Technical Advisory Bulletin (TAB)

Bulletin #: TBMELCO22A

Product: EMT16 PLUS, BRAVO II

Subject: 34799 and 34800 Control Board Failures

Pic. 2: Reworked PCBA with 5 Ohm Resistor

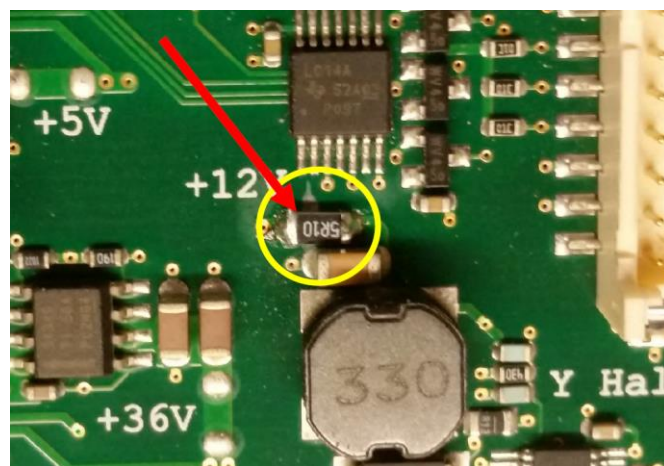
After considerable analysis the root cause is believed to be inrush current spikes that damage the motor driver chip, in most cases related to the y driver circuit.

For existing Control Boards on new EMT16 PLUS and BRAVO II machines, as well as refurbished Control Boards, a 5 Ohm resistor has been added to lower inrush currents, see example in pictures 1 and 2 below.

Pic. 5: Original Driver Chip on the left and re-soldered new driver chip on the right

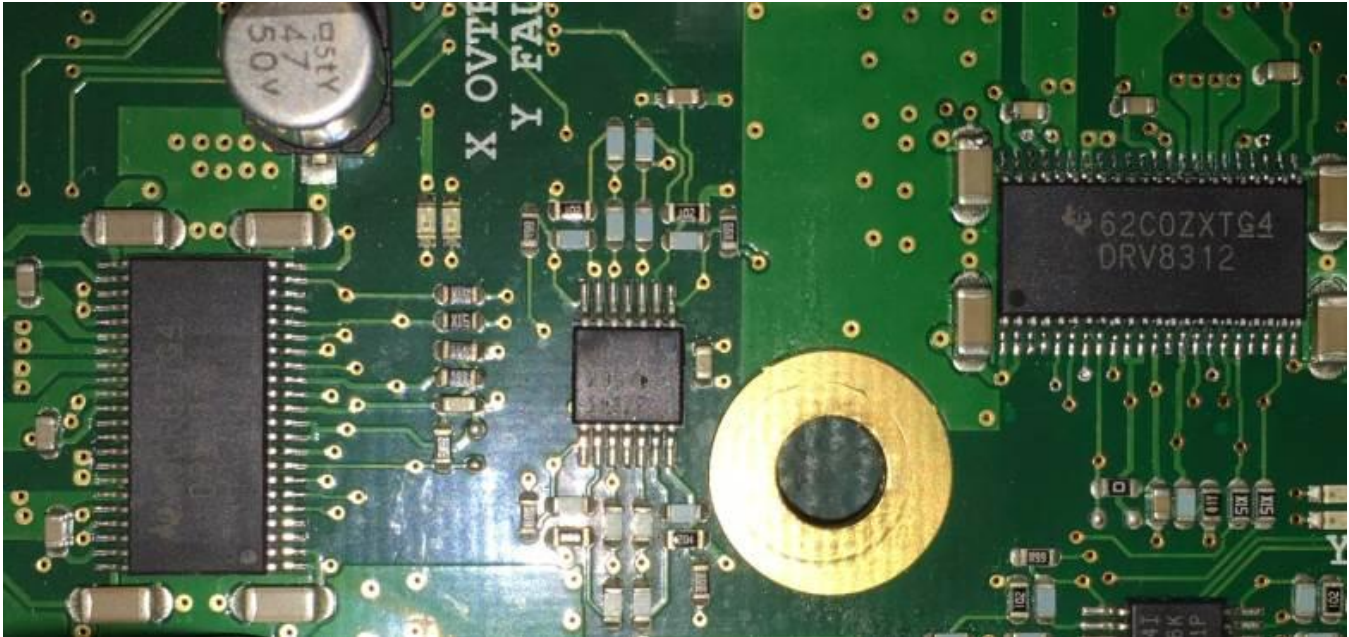
Unfortunately we have seen some of the reworked boards fail with the same symptoms. It is believed that the reason for these repeated failures is the fact that the driver chip had been somewhat compromised prior to the resistor rework being applied to boards that had already been run in machines.

For this reason Melco started to replace the y-motor driver chip, in addition to adding the resistor, on all refurbished boards, starting on November 8, 2017. These boards are also marked with a red dot but can be distinguished by the somewhat irregular solder distribution around the y-motor chip pins, see picture below. Due to the quality of the rework, and therefore the fact that it is hard to tell whether the motor driver chip had been replaced, in case one of these second wave reworked boards fails in the field, the board in question needs to be sent back to Melco for final determination/analysis.
